Career Technical Education Building
Payette School District #371
915 S. Main Street
Payette ID 83661
Tenant Improvement

Clarification #1

The following additional information have been added to the attached sheets and clouded as clarification #1 and shall be incorporated into the project and project construction estimates:

Sheet A1.00

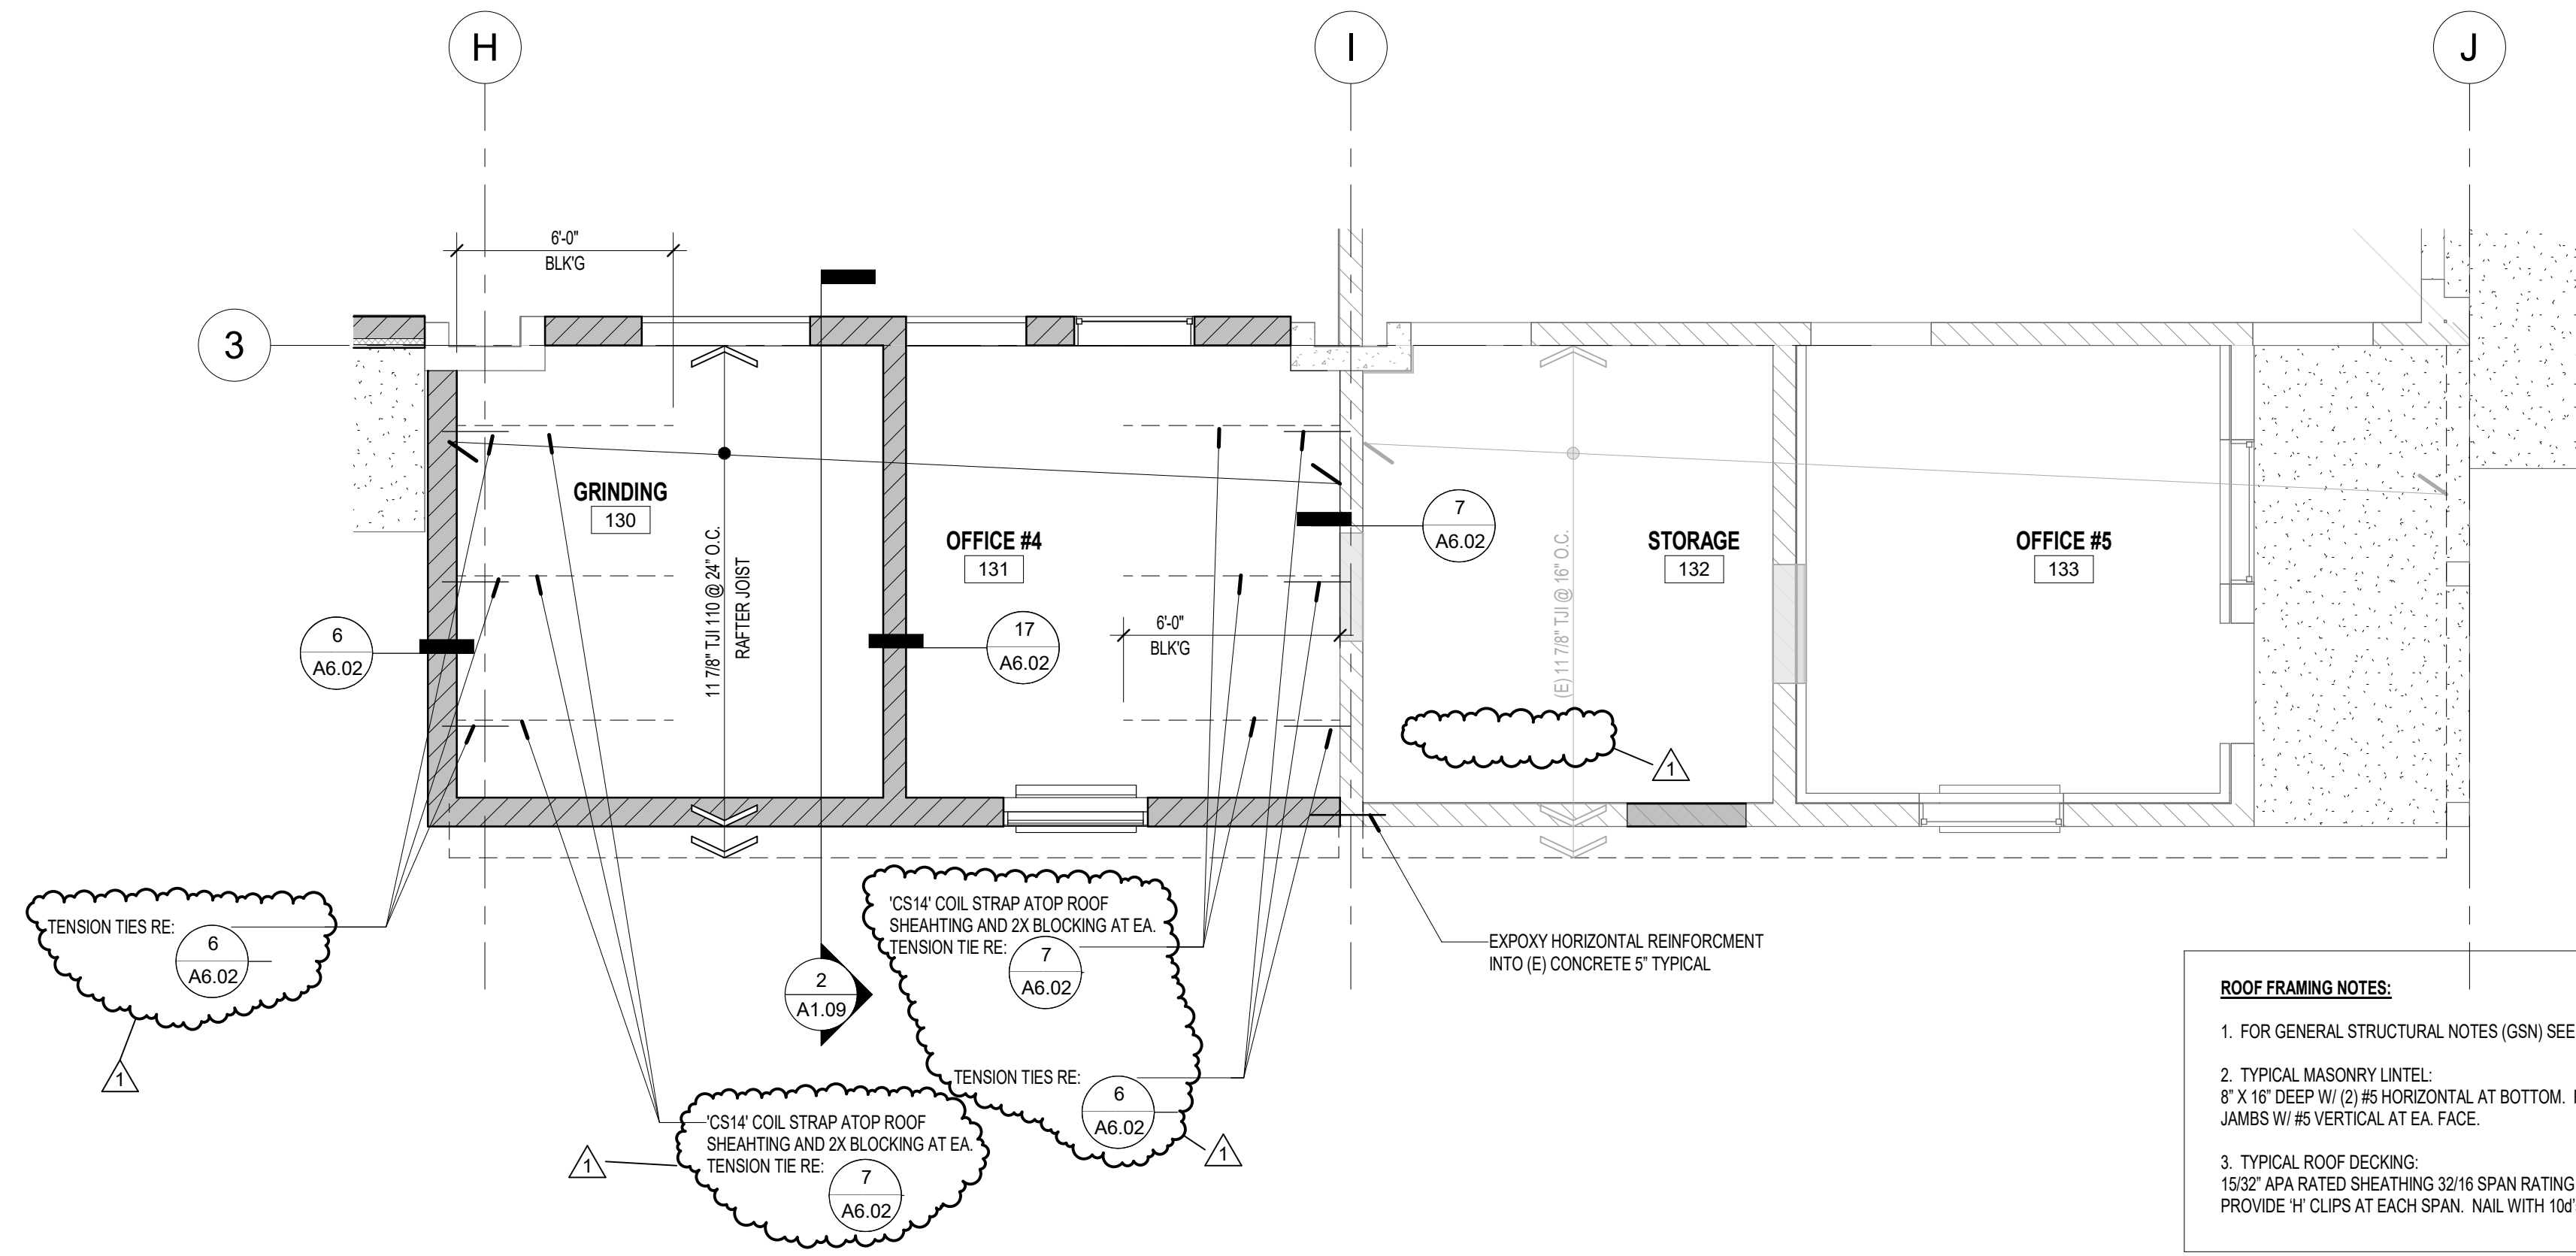
- Wall type legend interior metal stud framing basis of design for metal stud framing. Wall Type A, B, C, D.
- Wall Type E furring for metal finish.

1 ENLARGED FRAMING PLAN
SCALE: 1/4" = 1'-0"

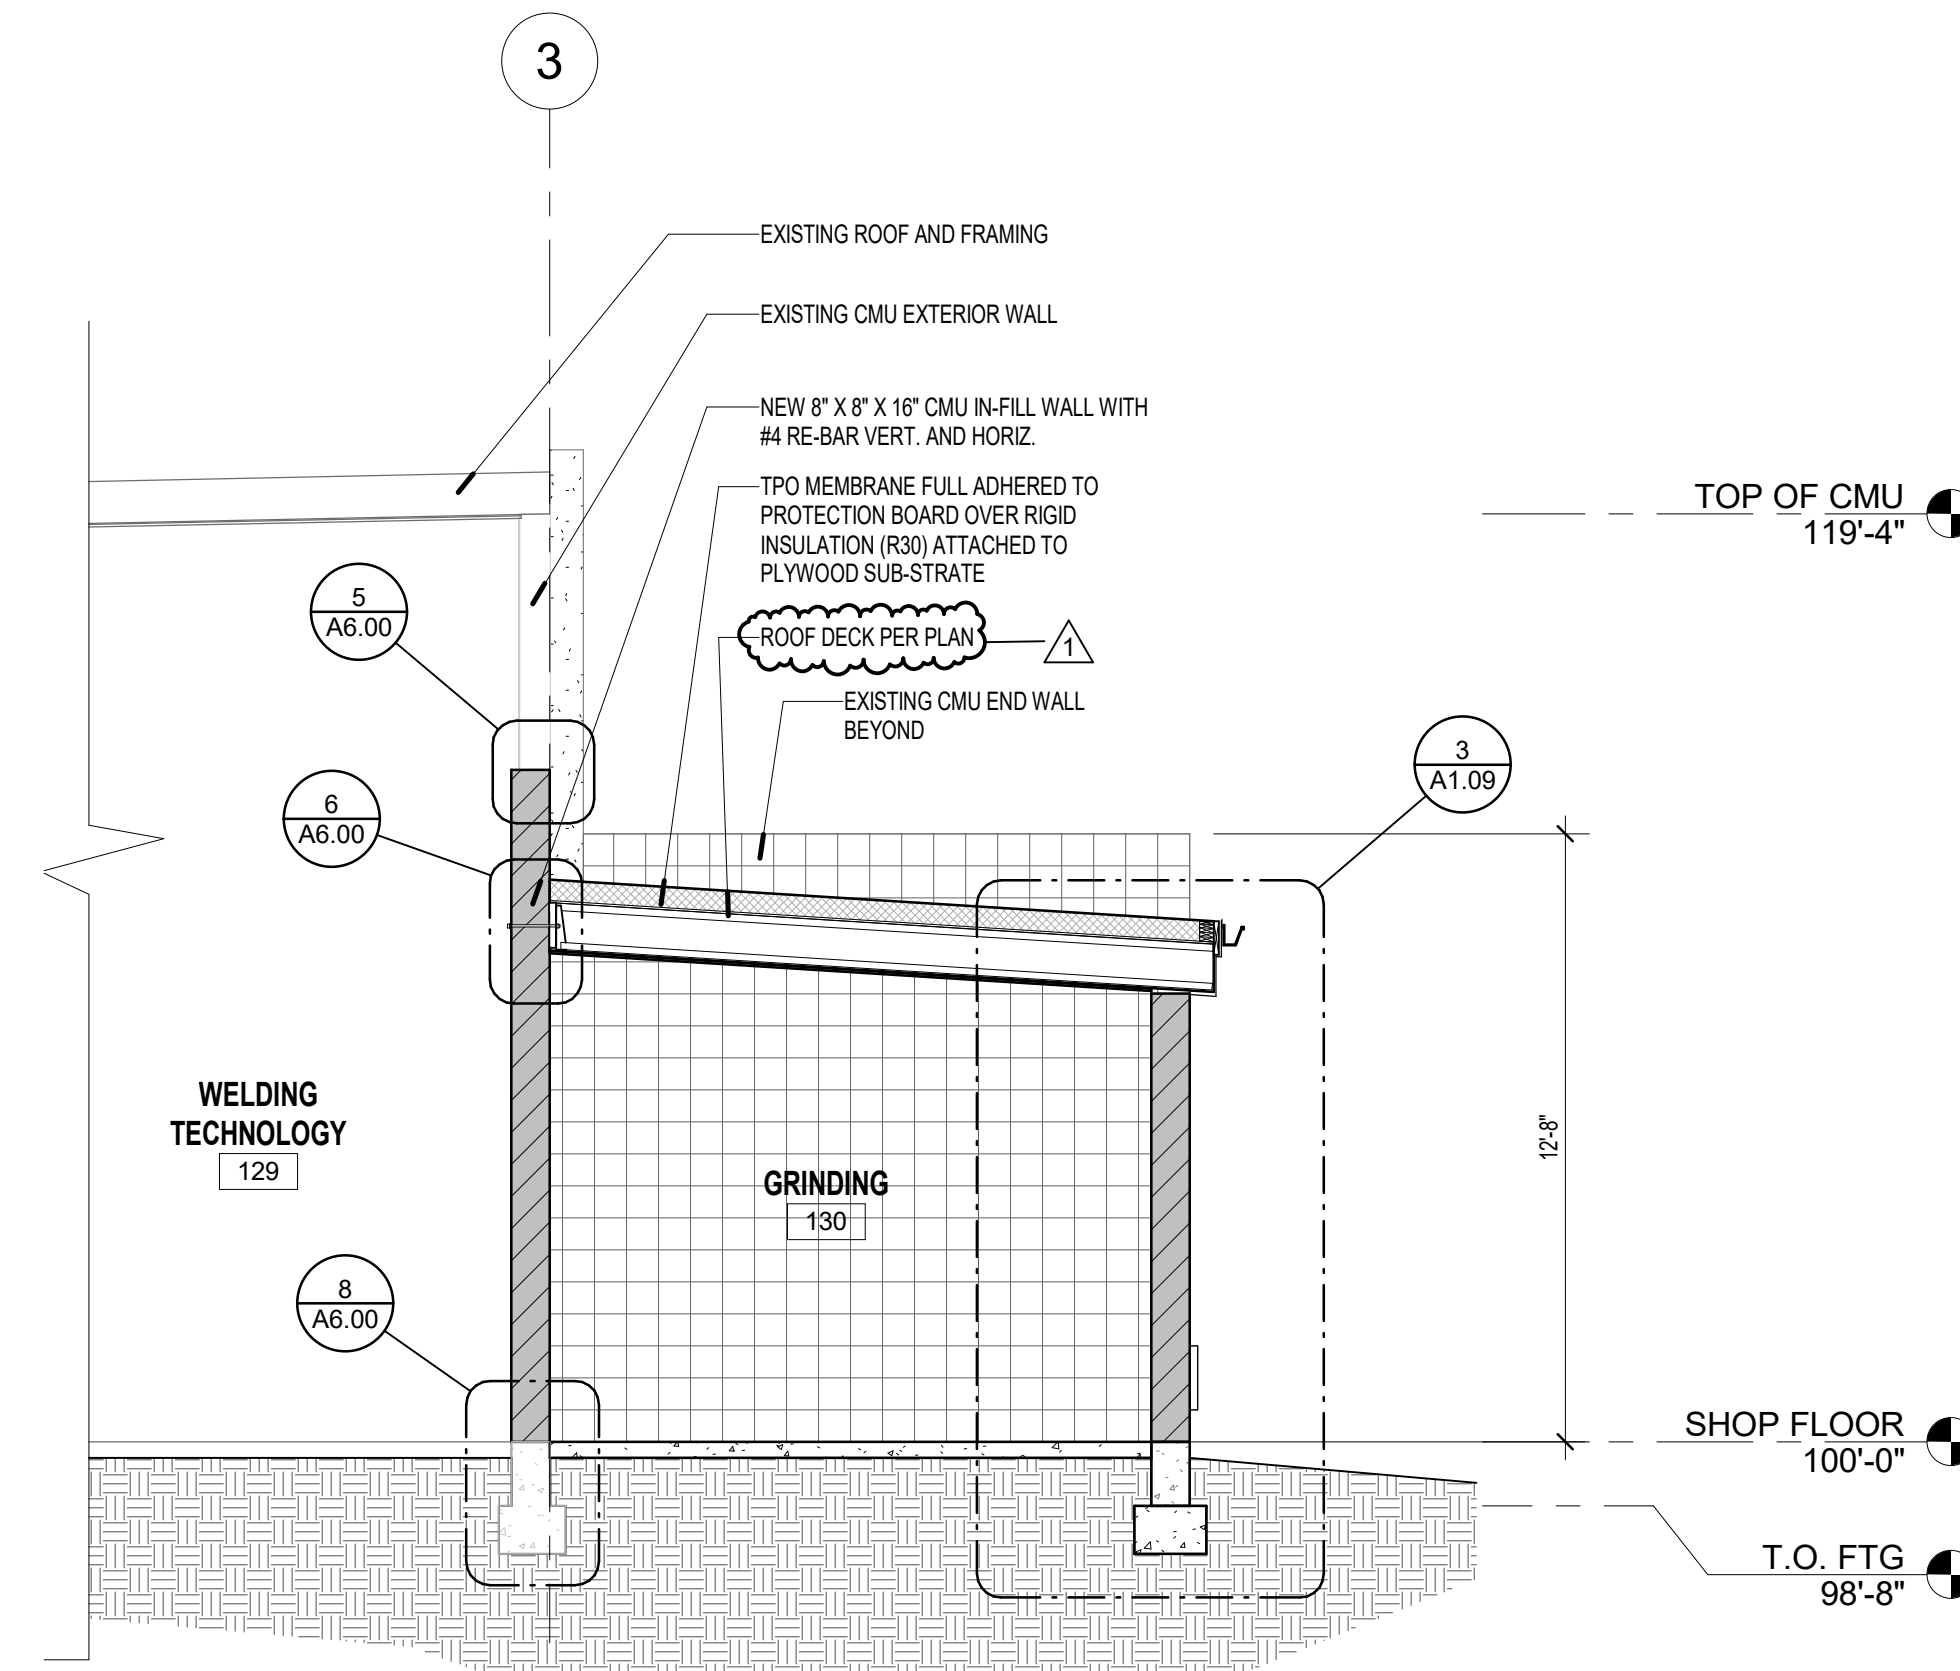
- Added information to Detail 1 – Enlarged Framing Plan
- Added Information to Detail 2
- Added Information to Detail 3
- Added Detail 4
- Added Detail 5
- Added Detail 6

1 BUILDING CROSS SECTION
SCALE 1/8" = 1'-0"

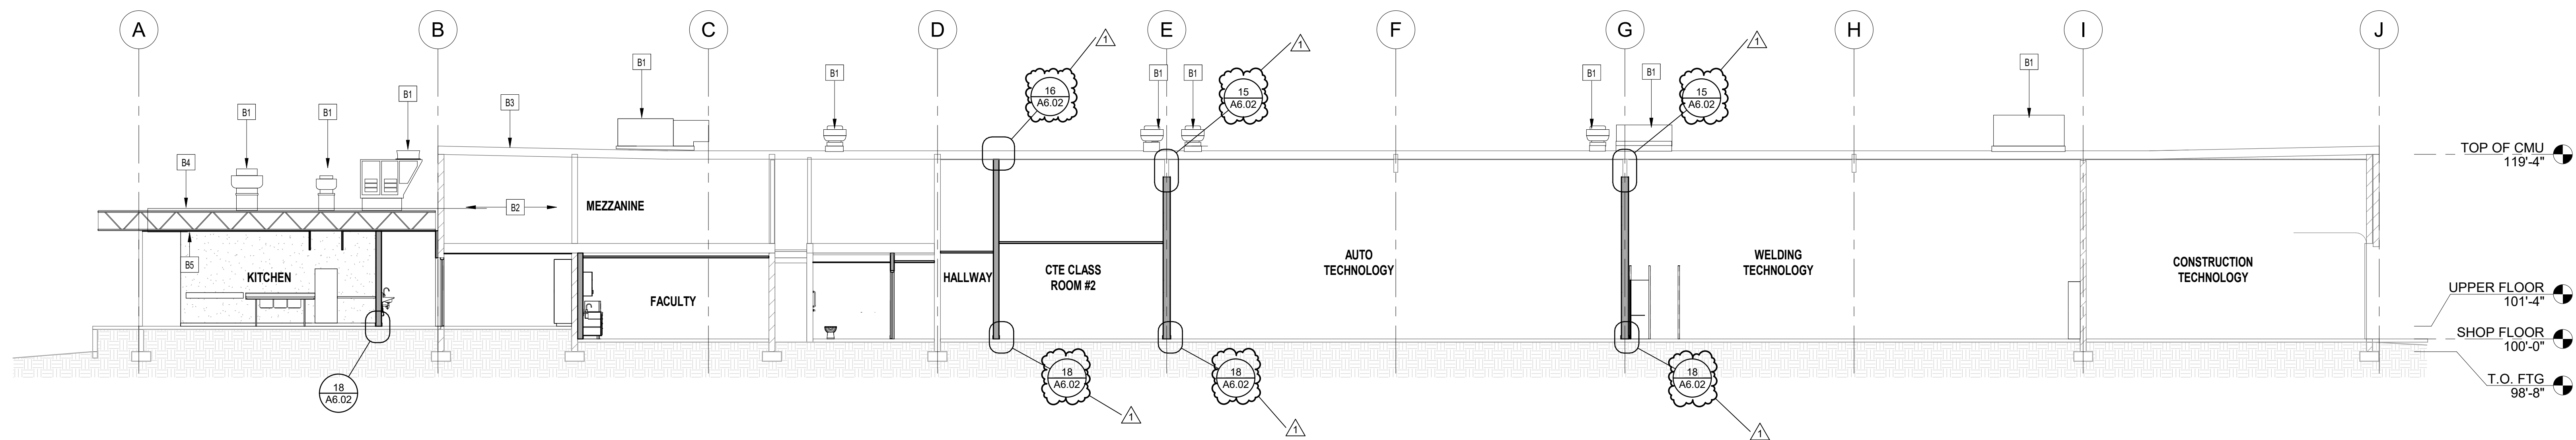
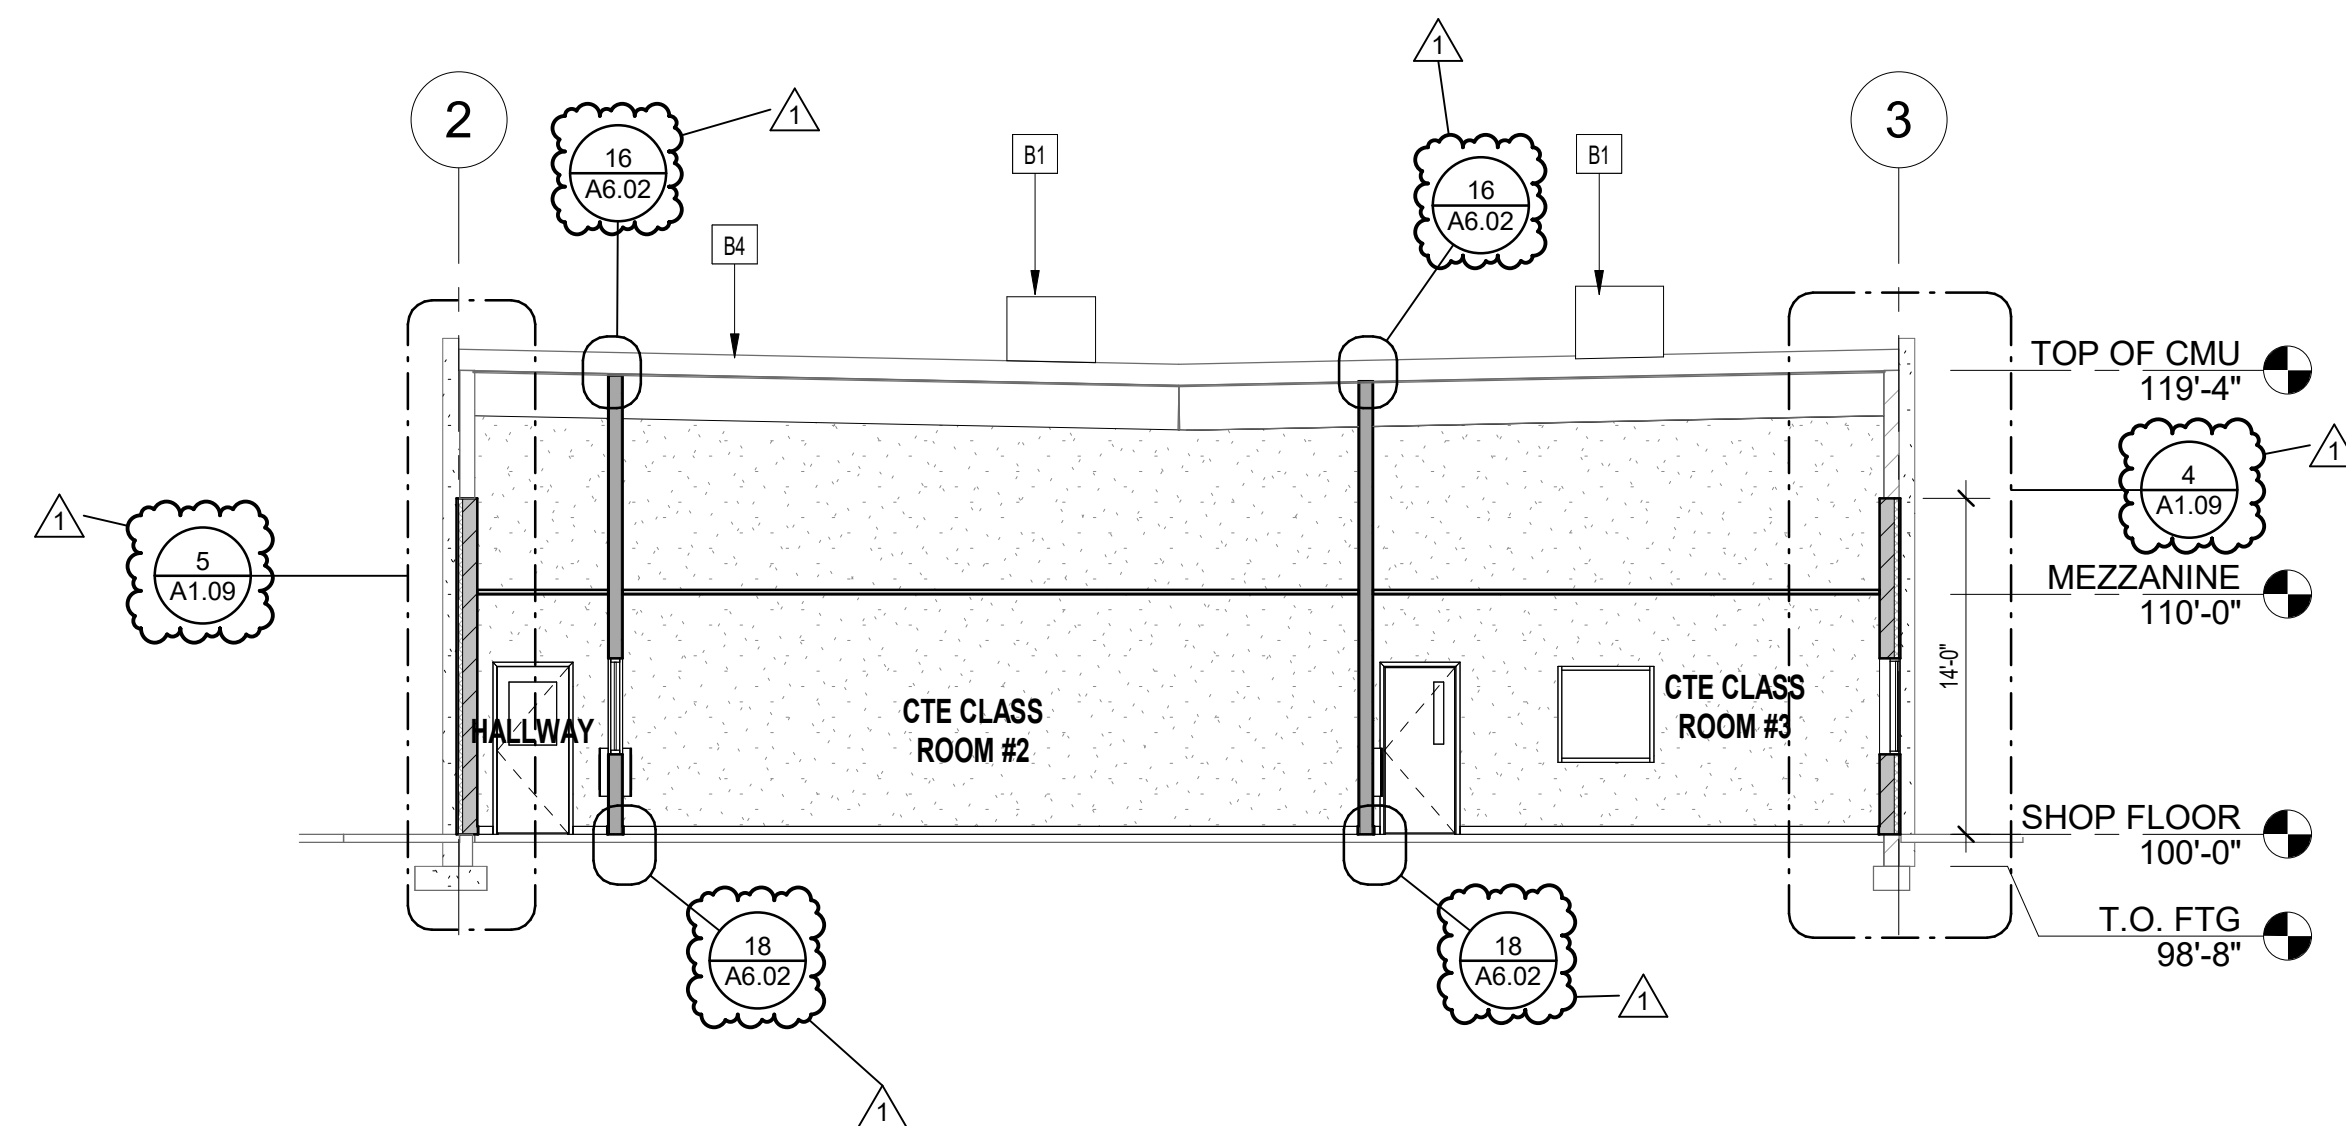
- Building Sections 1-3 – Added partition head of wall references

1 UPPER CABINET
SCALE 3/4" = 1'-0"

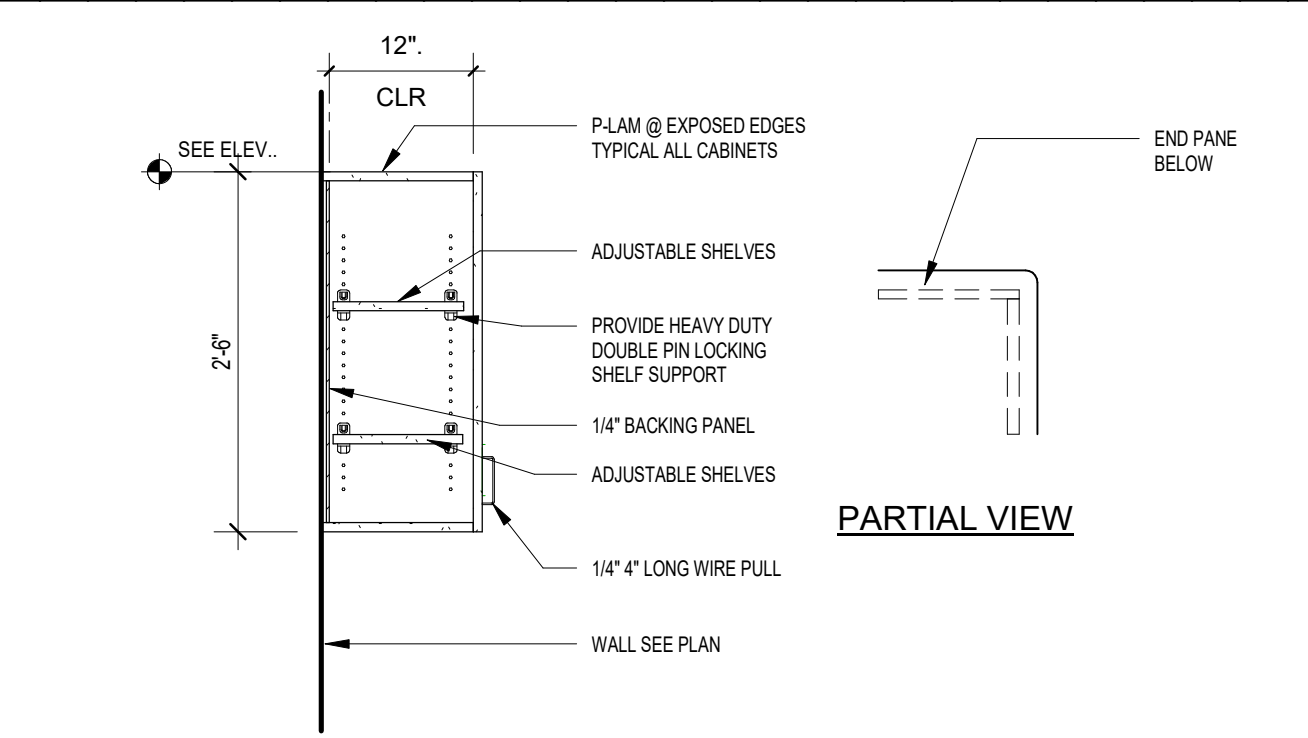
- Details 1 thru 4 – Clarified casework details
- Details 6 and 7 – Added information
- Added Details – 13 thru 18
